# TOWNSHIP OF ABINGTON

- a. **ACL-01-091219** Consider the Land Development Plan for the replacement of the Woodland parking garage structure at the southeast corner of the intersection of Woodland Road and Highland Avenue.
- b. **ACL-02-091219** Consider the Land Development Plan for 2907 Jefferson Avenue.
- c. **ACL-03-091219** Consider a motion to award the Base Bid for the 2016 Growing Greener Project for Stormwater Management BMP Control Measures at Roychester Park and Evergreen Manor Park to Land Tech Enterprises, in the amount of \$174,774.00 and to authorize utilizing MS4 program money from appropriated MS4 program funding; if necessary.

**SUBJECT: ABINGTON HOSPITAL WOODLAND ROAD PARKING GARAGE  
1200 OLD YORK ROAD  
FINAL LAND DEVELOPMENT PLAN REVIEW NO. 2  
ABINGTON TOWNSHIP, MONTGOMERY COUNTY, PENNSYLVANIA  
PROJECT NO. 1926008R**

**SUBJECT: 2907 JEFFERSON AVENUE  
FINAL MINOR SUBDIVISION AND LAND DEVELOPMENT PLAN REVIEW NO. 3  
ABINGTON TOWNSHIP, MONTGOMERY COUNTY, PENNSYLVANIA  
PROJECT NO. 1926009R**

**CS1001**

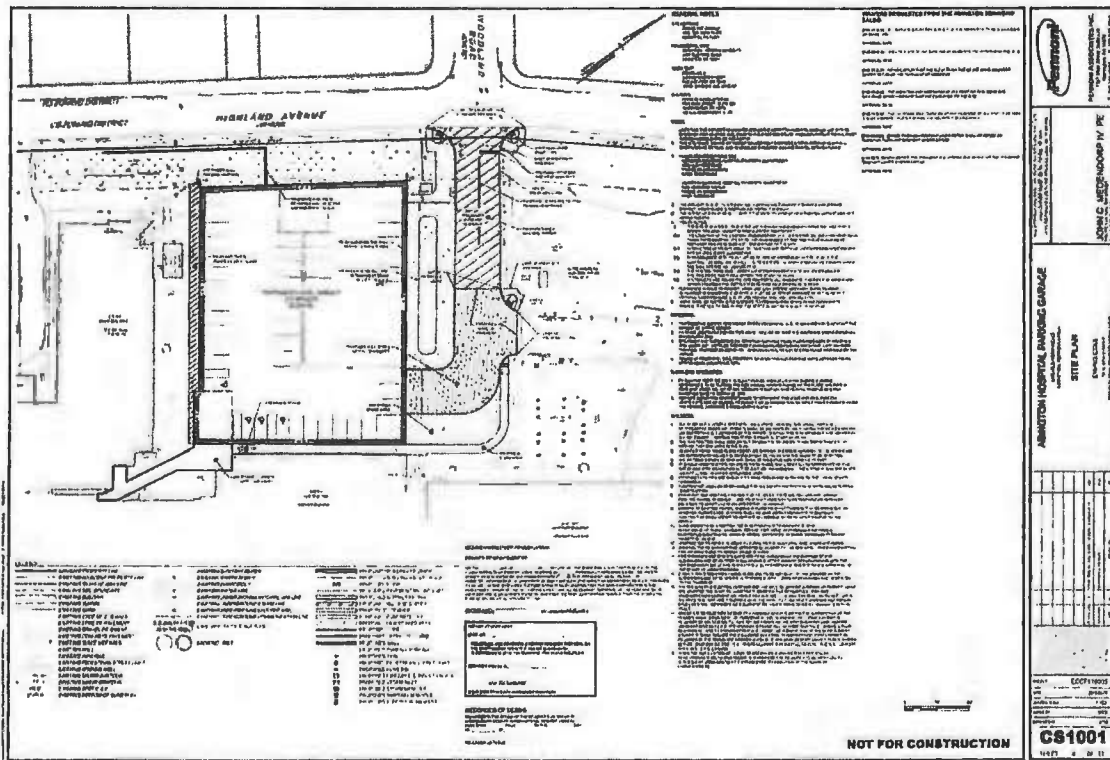
Abington Jefferson Health, the applicant, has submitted a special review request for a new parking garage on the Abington Hospital-Jefferson Health campus. The applicant proposes to demolish the existing Woodland Garage, and replace it with a new one. The site is located in the CS Community Service District. The site is served by public sewer and water. The plan is dated March 29, 2019.

**CS1001**  
SHEET 4 OF 13

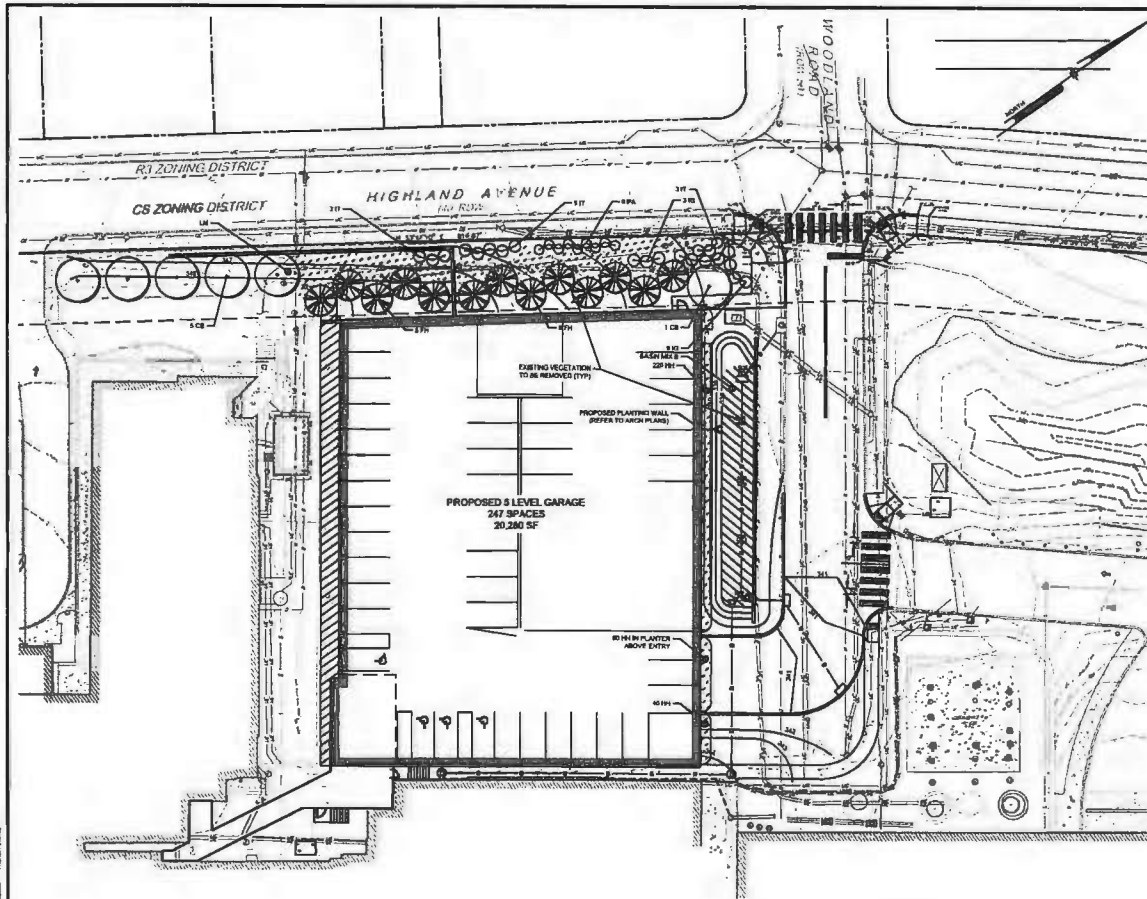
11. *The owner's certification on Sheet 4 must be revised to reflect the language provided in Section 146-12.C.(2) and include the name of the property owner.*

12. *The Board of Commissioners certification in Section 146-12.D must be provided on the plan.*

15. *In accordance with Section 146-27.E, sidewalks shall be extended to the curbline with ramps for adequate and reasonable access across curbs by physically handicapped persons, including those in wheelchairs. Per Sheets 4 and 9, Type I handicap ramps are proposed at the intersection of the site driveway and Highland Avenue, and internal to the project site. The plan must be revised to include detailed ramp design consisting of dimensions, spot elevations, and slopes. In addition, continental style crosswalks must be shown on the plan at the handicap ramps and details of the crosswalks must be provided on the plan. We suggest larger scaled detailed plans be provided for clarity. Review of all handicap ramps will be completed upon receipt of the detailed plans.*

**The owner's certification has been revised on Sheet 4 (CS1001) to reflect the language in 146-12.C.(2).**

**The certification has been provided on Sheet 4 (CS1001).**

**The ramps have been revised to show dimensions, spot elevations, and slopes. Crosswalks have been added to Sheet 4 (CS1001) and a crosswalk detail has been added to Sheet 11 (CS6002).**
